Trott Brook Farms Elk River, Minnesota

LIFT STATION

DATE 6-1-99 SHEET 27 OF 32

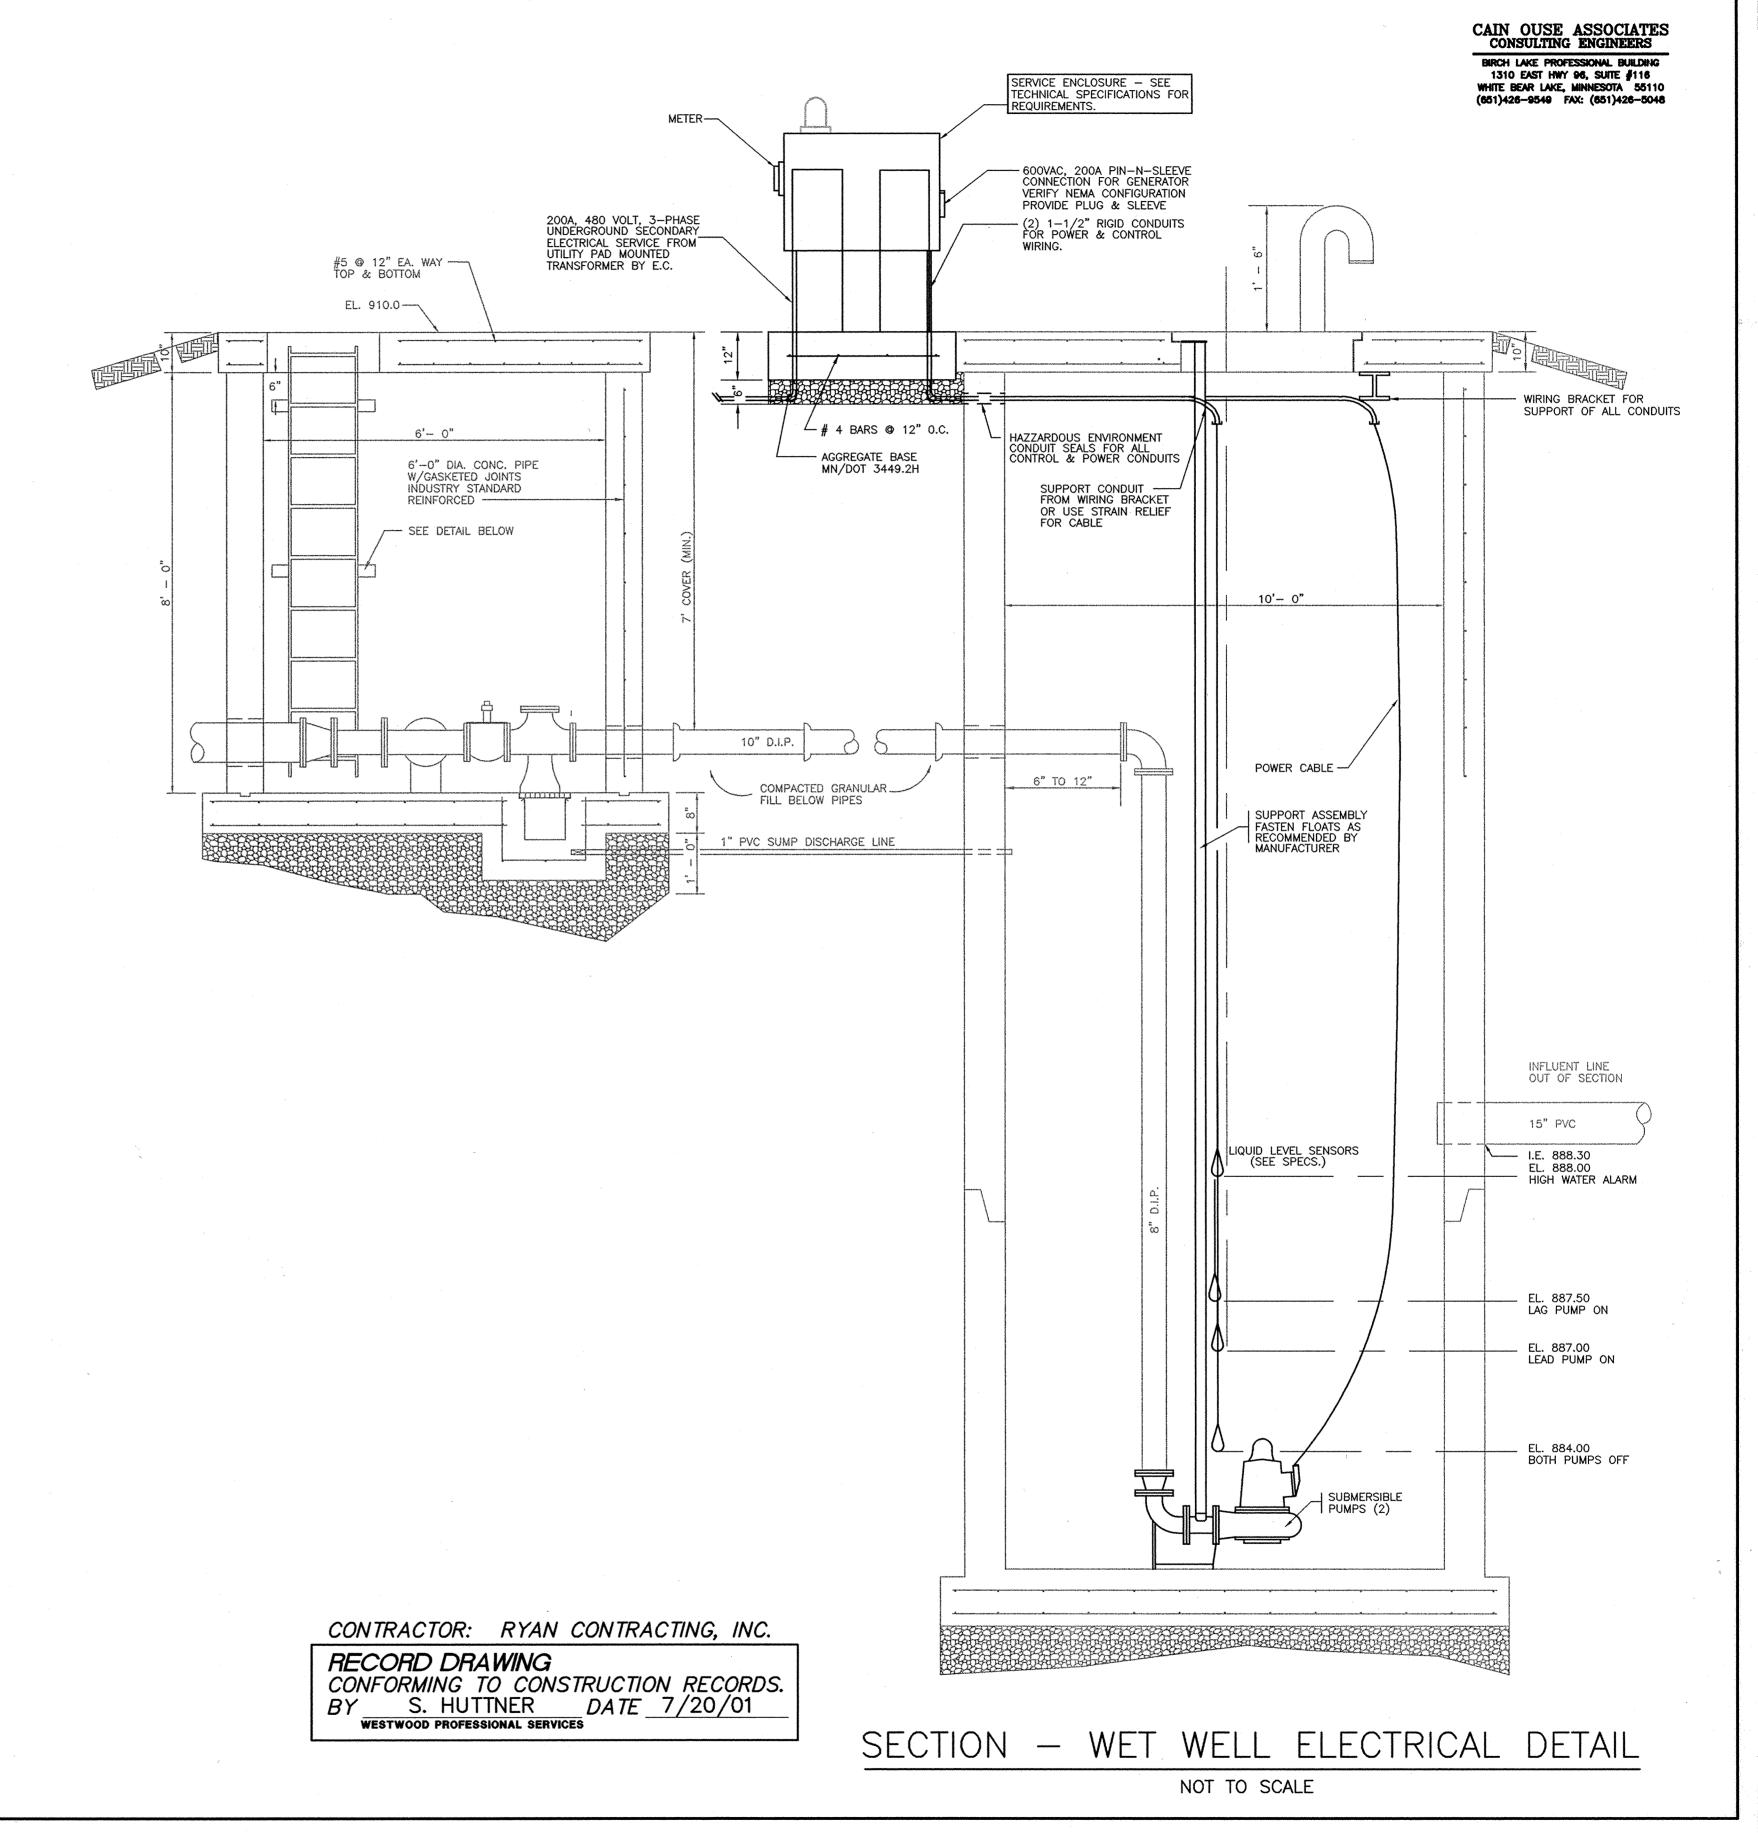
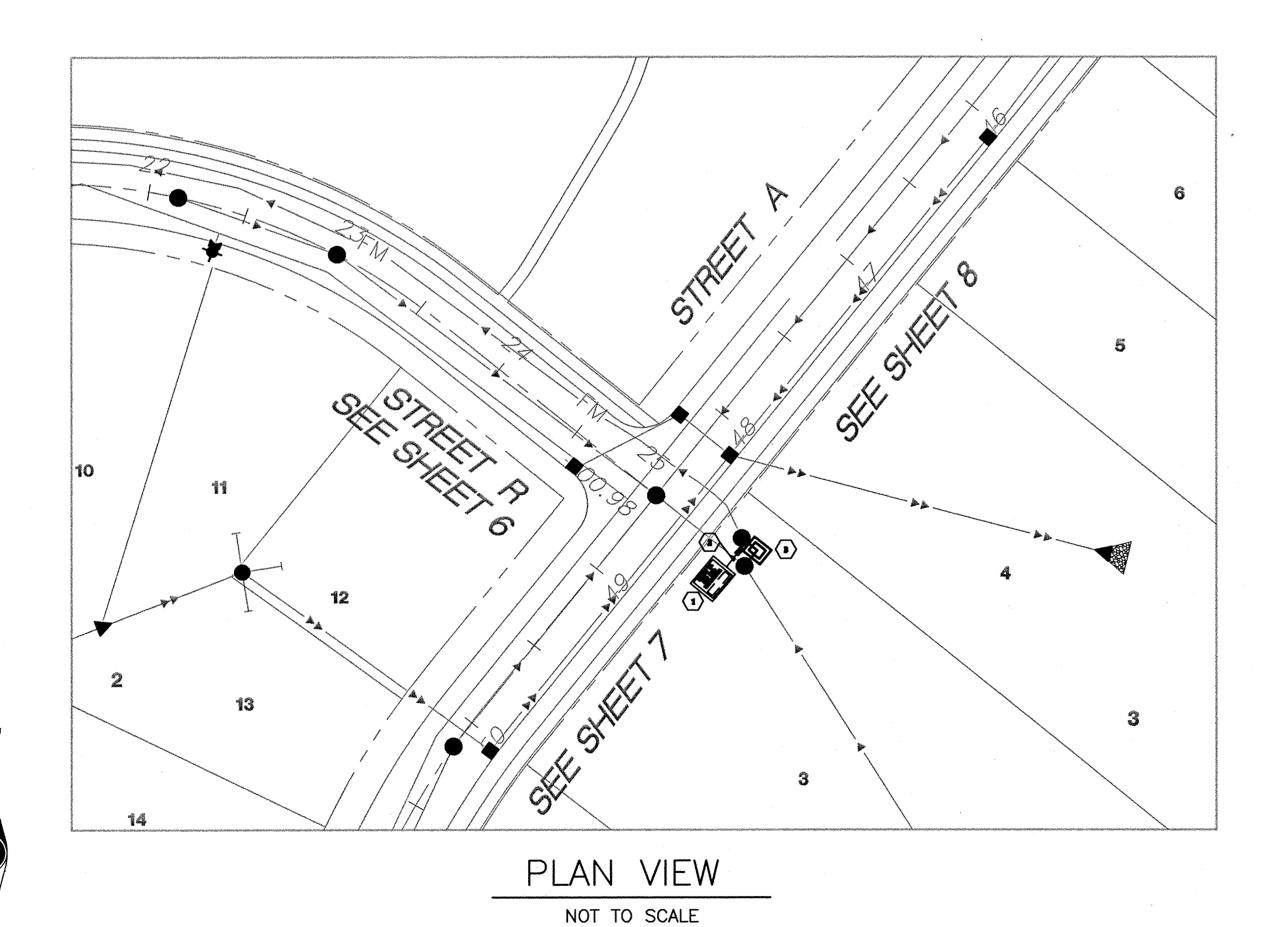
SWITCH ON VALVE VAULT ??
